HEARING STATEMENT PREPARED ON BEHALF OF ANJUMAN-E-ISLAHUL- MUSILMEEN

**LONDON BOROUGH OF NEWHAM LOCAL PLAN
SUBMISSION STAGE (REGULATION 22)**

MATTER 3 - QUESTION 3.2

NOVEMBER 2025

Figure 1: Map showing the boundary of TBZ16, N7.SA1 and AeIM's site ownership (source: Montagu Evans).

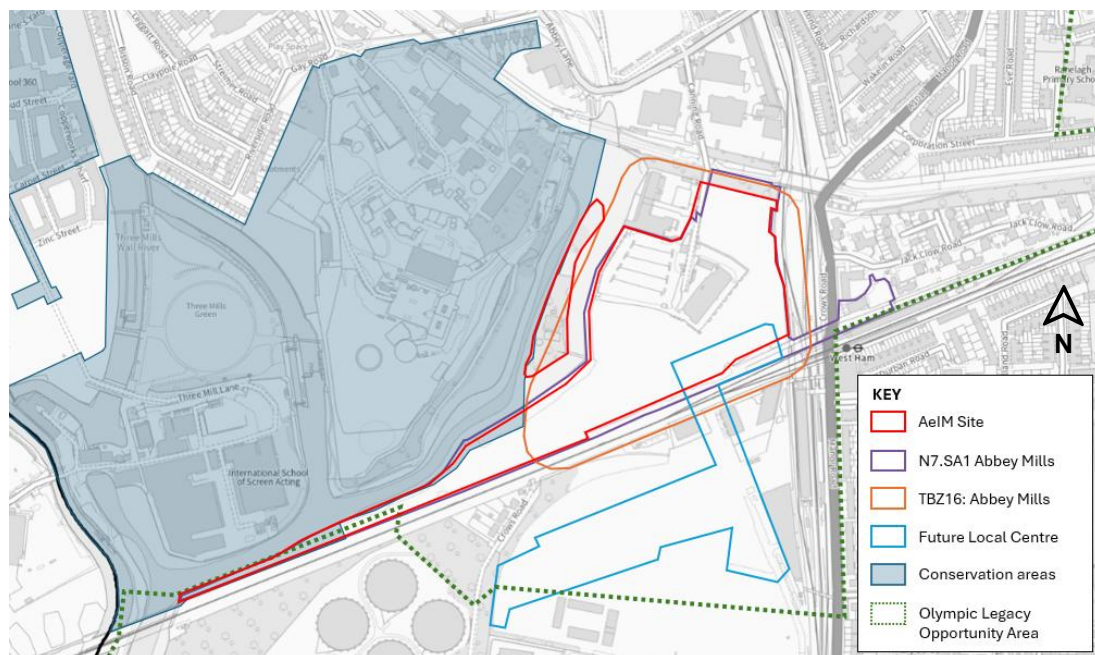
- 1.9 Modifications are also required to the boundary of TBZ16 for the following reasons:
- 1.9.1 The proposed boundaries of TBZ16 and N7.SA1 are not aligned, with the latter extending beyond the boundary of TBZ16 (**Figure 1**). The supporting text of emerging Policy D4 states that development of tall buildings outside TBZs "*will be considered a departure from the plan*". Contradicting this, the entirety of N7.SA1, including land outside TBZ16, is identified as suitable for tall buildings. This is a fundamental inconsistency within the Draft Plan.

- 1.9.2 As drawn, the boundary of TBZ16 omits developable areas of the Site from the TBZ, meaning the Draft Plan does not allow for the land within N7.SA1 to be fully optimised.

Figure A1: Map of TBZ16 with required boundary change annotated by dashed orange line (source: Montagu Evans).

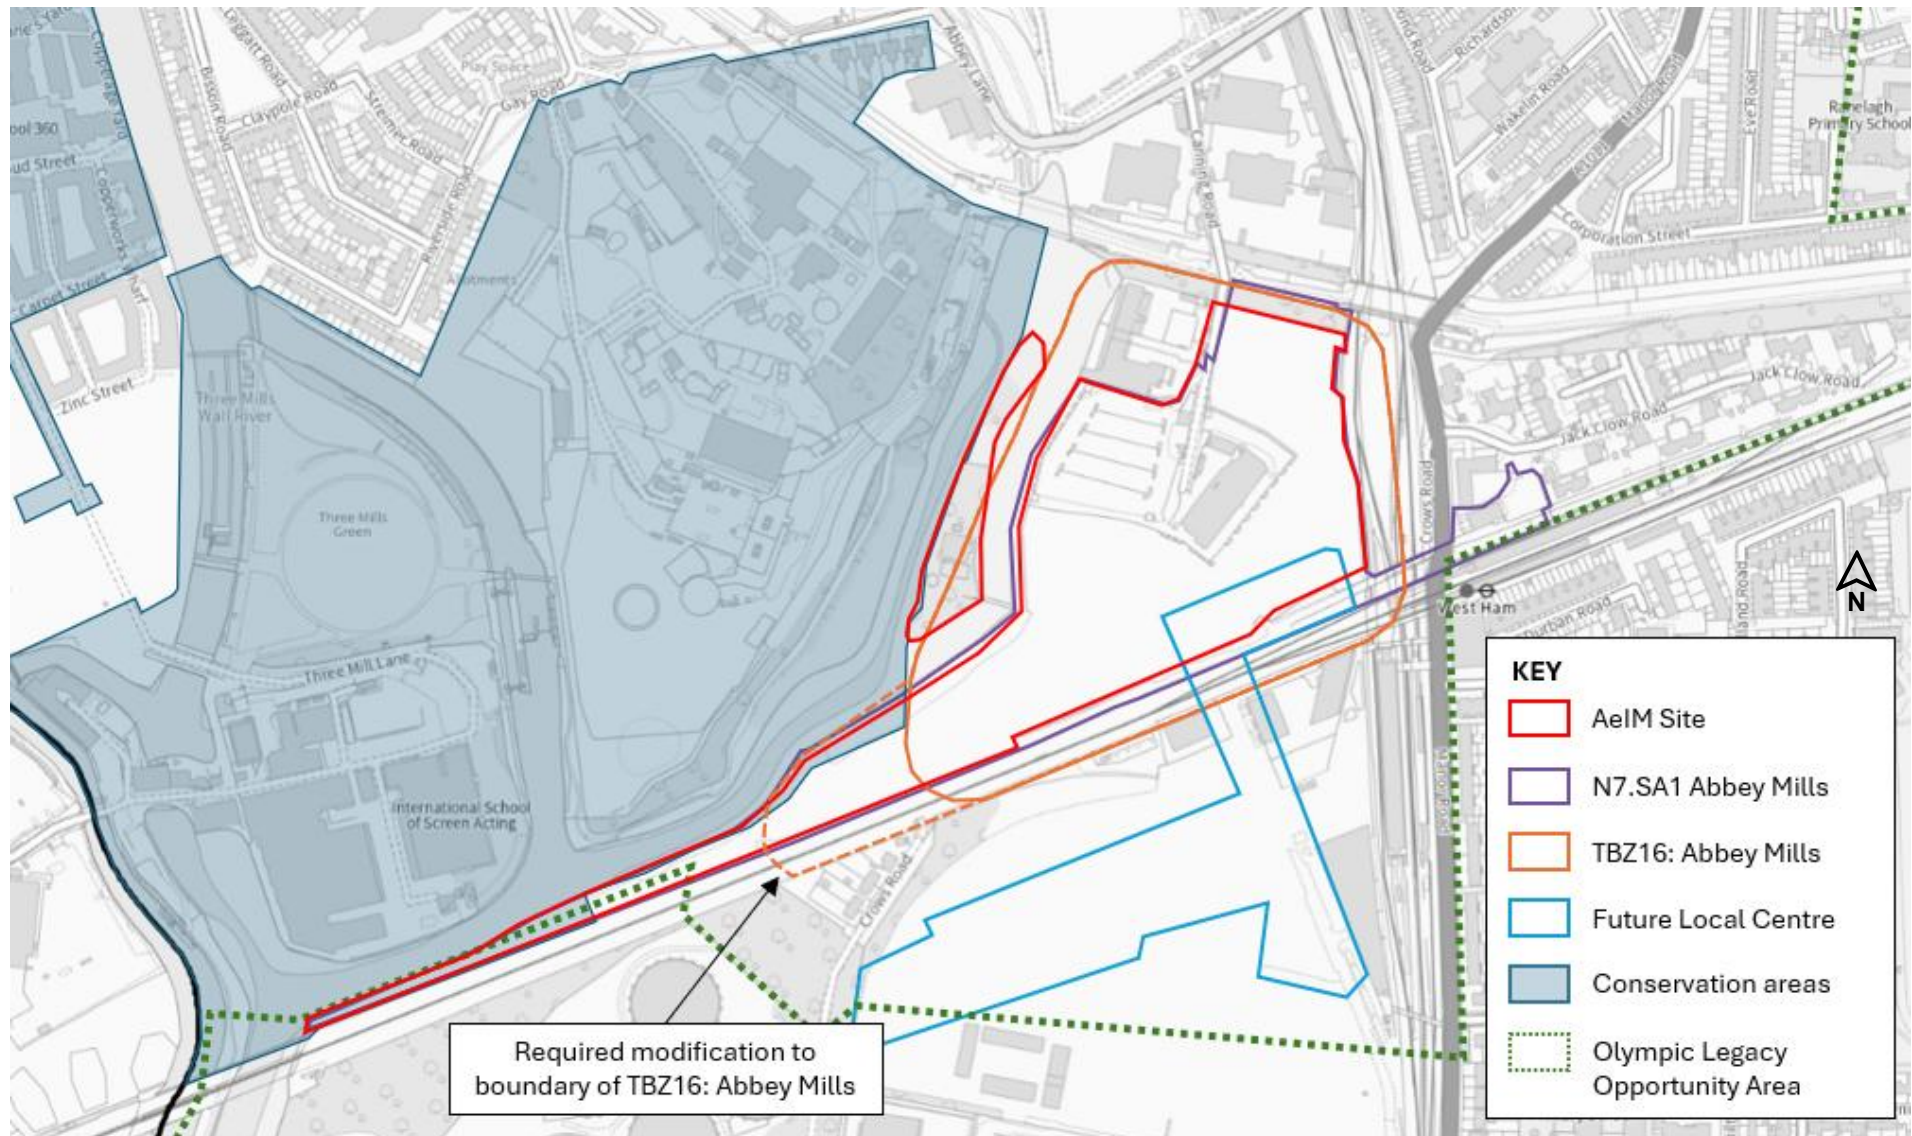
AeIM's masterplan demonstrates that tall buildings can be accommodated on the part of the Site which falls outside of the western boundary of TBZ16 without adverse heritage or townscape impacts, and while delivering the 2ha local park as required by the allocation (see **Appendix 1**). On this basis, the boundary of TBZ16 should be amended to include the area to the west of the existing TBZ16 boundary.

The Map of Newham's Tall Building Zones on page 79 of the Draft Plan should be amended to reflect the below change to the boundary of TBZ16:
